REMARKS

MARK-UP COPY

FIG. 5

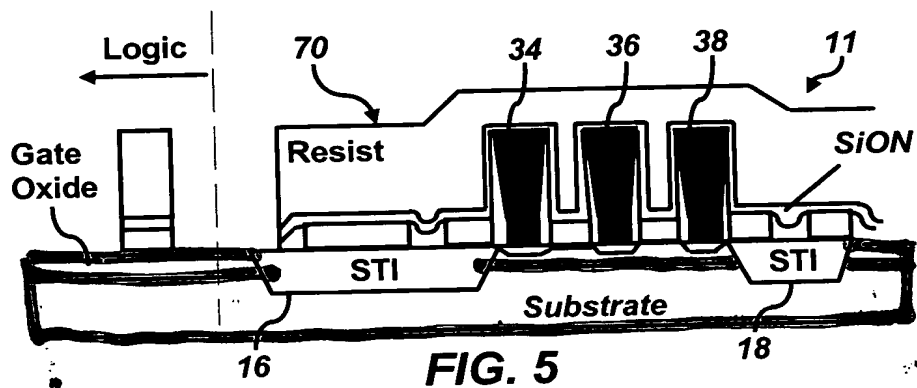
Regarding Fig. 6, the Examiner argued that the SiON layer is not indicated. Applicant points out that Fig. 6 shows a step after SiON was removed. SiON appears in Fig. 5, which has modified to indicate SiON. It can be surmised from the drawings that SiON was added after Fig. 4 and removed after Fig. 5, but prior to the step shown in Fig. 6. Therefore, Applicant therefore asserts that this issue has now been removed.

FIG. 10

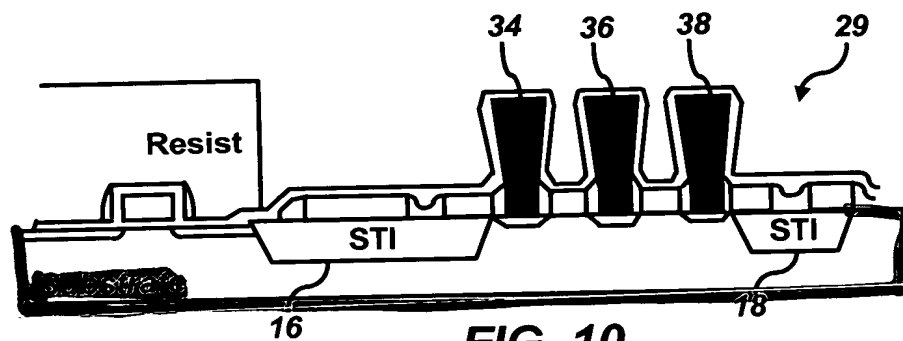
Regarding Fig. 10, the Examiner stated that space TEOS is not shown. Applicant points out that it is not necessary to show a space TEOS, because the

specification clearly points out that Fig. 10 shows the results of a TEOS wet dip. Also, TEOS is discussed thoroughly with respect to Fig. 17. The figures in their totality, including the specification and background provide sufficient enablement thereof. Applicant therefore asserts that this issue has now been removed.

FIG. 11

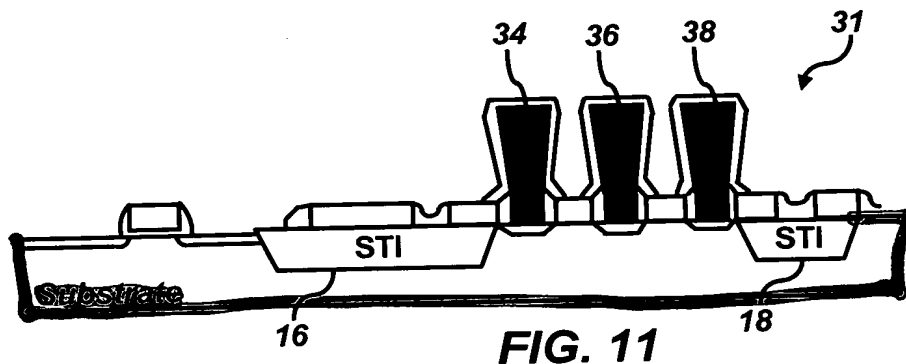
Regarding Figs. 10-15, the Examiner stated that it is not clear what is the material on 34, 36, and 38. The Applicant asserts that it is clear that a resist material is located on 34, 36, and 38 at various stages in the processes of Figs. 10-15. Therefore, Applicant therefore asserts that this issue has now been removed.

FIG. 12

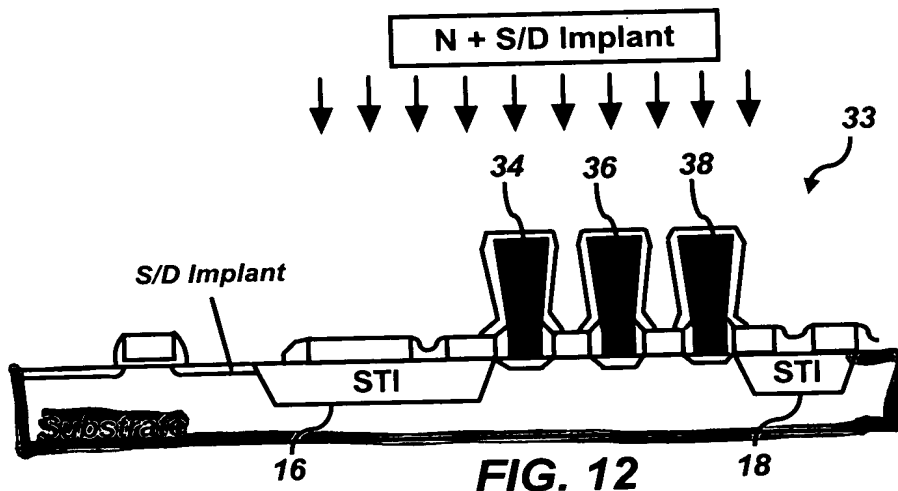
Regarding Fig. 12, the Examiner stated that it is not clear whether S/D implant is done only in the DRAM area. Applicant respectfully disagrees with this assessment. The box labeled "N+S/D Implant" is located sufficiently above the substrate and components thereof to indicate that the implant operation occurs across the entire top thereof. Applicant therefore asserts that this issue has now been removed.
